**Project Name: UNIVERSITY OF CALIFORNIA, MERCED
CLASSROOM AND OFFICE BUILDING 1 RENOVATION**

Project No.: 908078

ADDENDUM NO. 3
to the
CONTRACT DOCUMENTS
April 6, 2020

2ND FLOOR LIFE SAFETY PLAN (REFERENCE ONLY)
 Drawn By: AC
 Checked By: MP/PW
 Project Number: 2019031
 Sheet Number: ID0.3.02

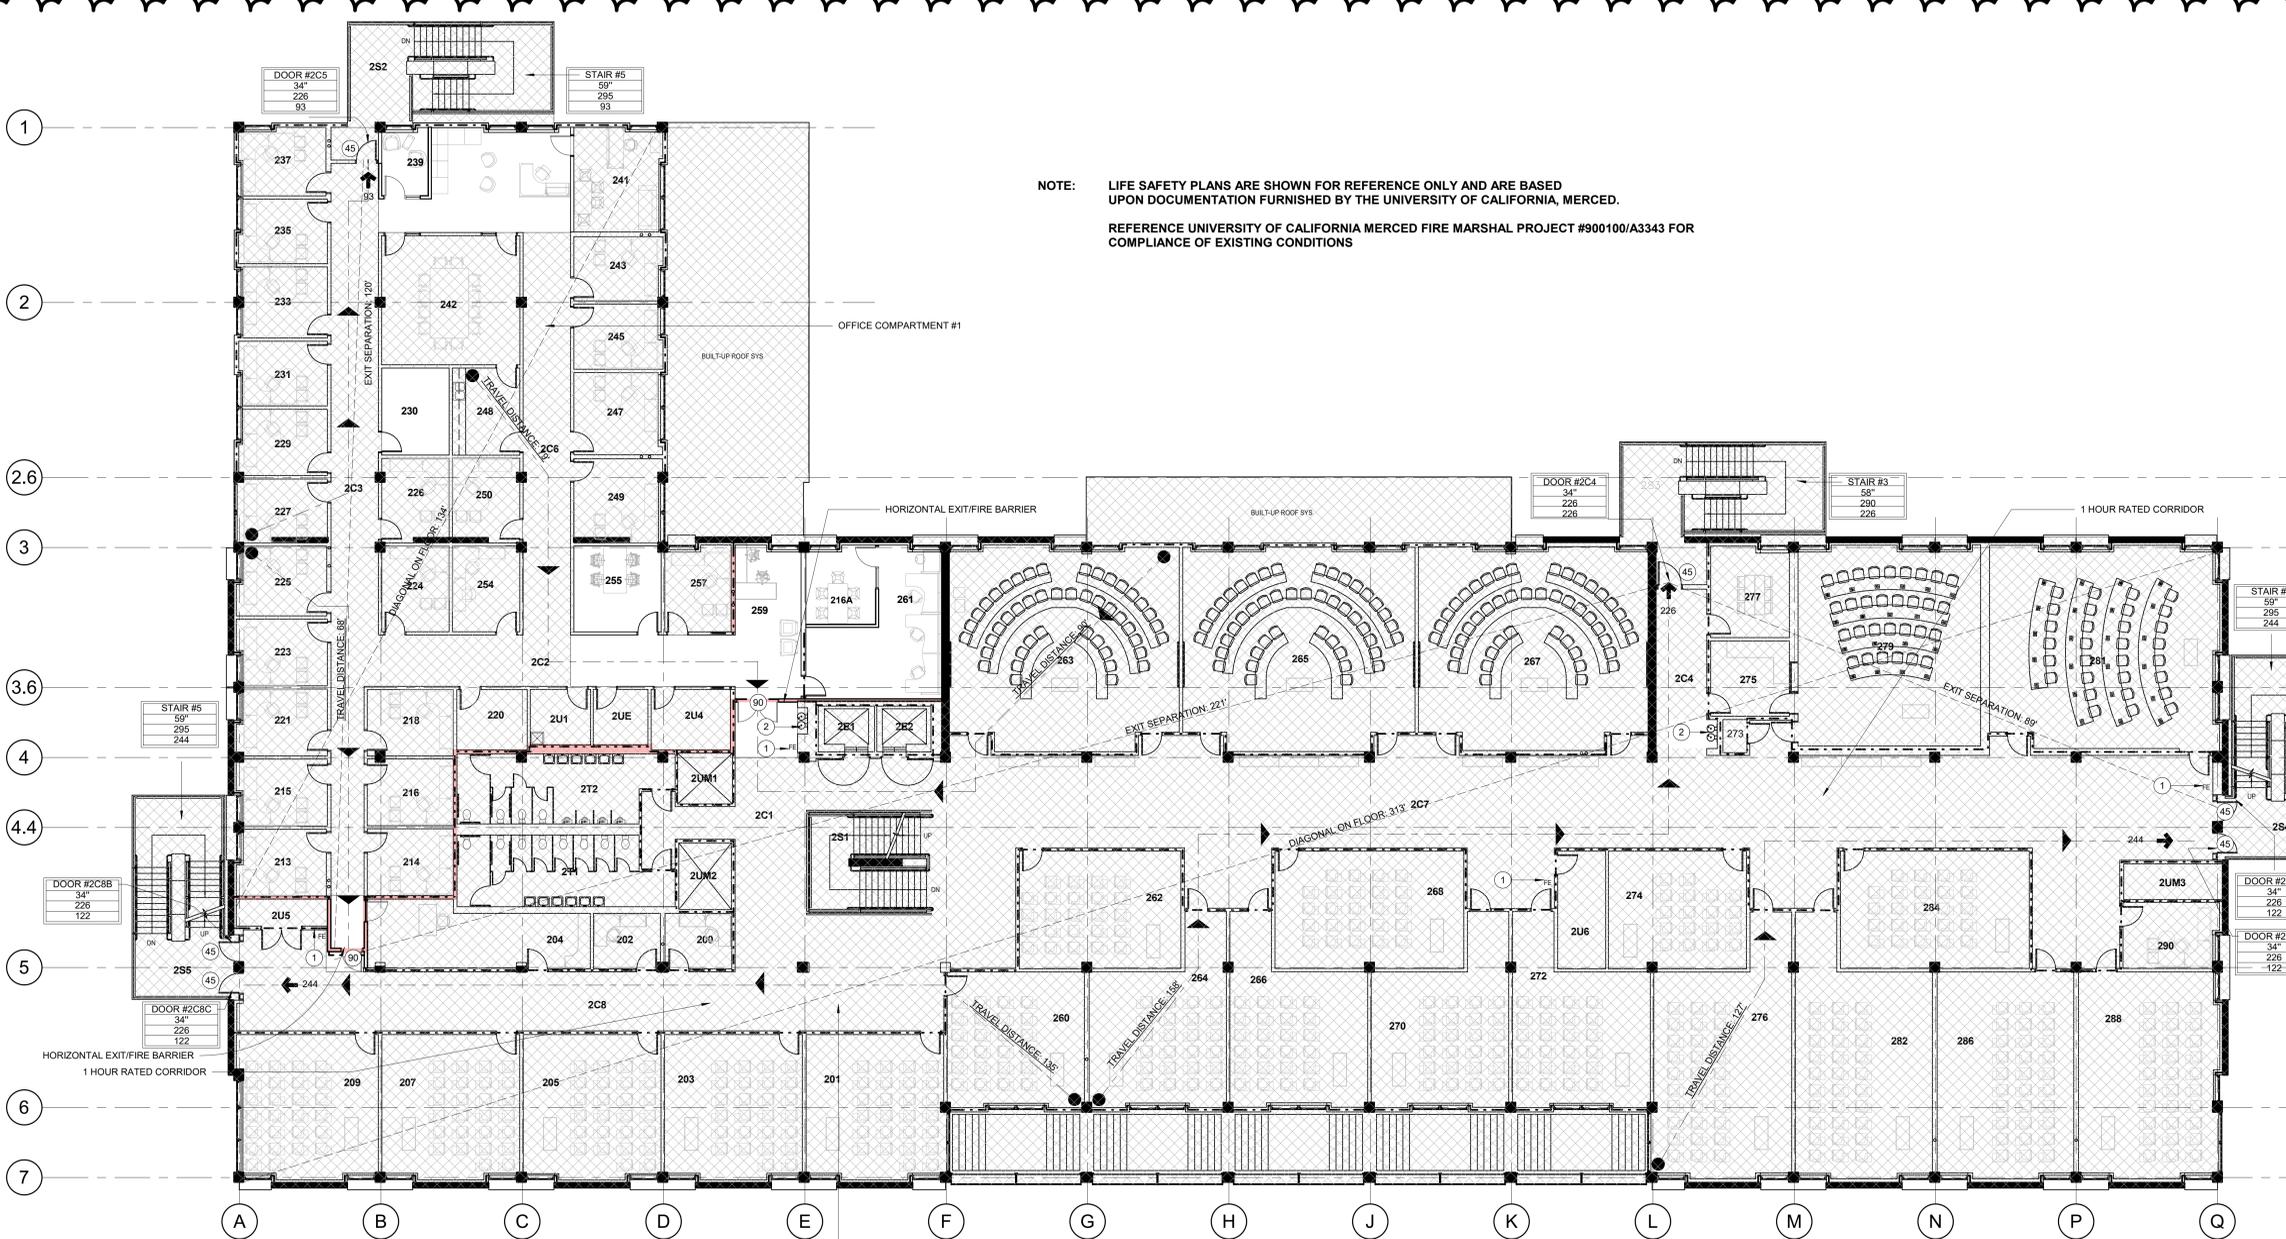
ID03.01	1 ST FLOOR LIFE SAFETY PLAN (REFERENCE ONLY)	1. Revised Occupancy of corridors and compartment areas. Added seats count and plumbing fixture calculation.
ID0.3.02	2ND FLOOR LIFE SAFETY PLAN (REFERENCE ONLY)	1. Revised Occupancy of corridors and compartment areas. Added seats count and plumbing fixture calculation.
ID0.3.03	3RD FLOOR LIFE SAFETY PLAN (REFERENCE ONLY)	1. Revised Occupancy of corridors and compartment areas. Added seats count and plumbing fixture calculation.
ID1.03	2ND FLOOR DEMOLITION PLAN	1 Callout of new demo wall detail. 2/ID1.03
ID1.05	3RD FLOOR DEMOLITION PLAN	2. Add demo detail. 2/ID1.03
ID2.02	2ND FLOOR PARTITION PLAN	1. Revise Room Numbering
ID7.01	INTERIOR ELEVATIONS 1ST AND 2ND FLOOR	1. Callout of new wall detail. 11/ID8.02
ID7.02	INTERIOR ELEVATIONS 3RD FLOOR	1. Added Note #2
ID7.03	INTERIOR ELEVATIONS 3RD FLOOR	1. Added Note #2
ID7.04	INTERIOR ELEVATIONS 3RD FLOOR	1. Added Note #2

5 PARTITION S2KK HEAD
 SCALE: 6" = 1'-0"

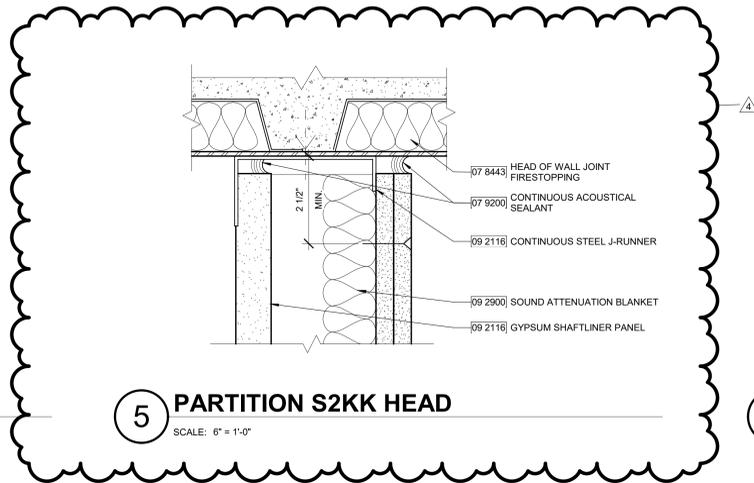
ID8.01	PARTITION HEAD AND BASE DETAILS	1. Head detail of S2KK wall
ID8.02	PARTITION AND TRANSITION DETAILS	1. Added "DISPLAY" to BP1
ID8.06	DOOR DETAILS, TYPES AND SCHEDULE	2. Added detail - A2CD @ S2KK TRANSITION
ID8.09	AV DETAILS (REFERENCE ONLY)	1. Added Jamb detail
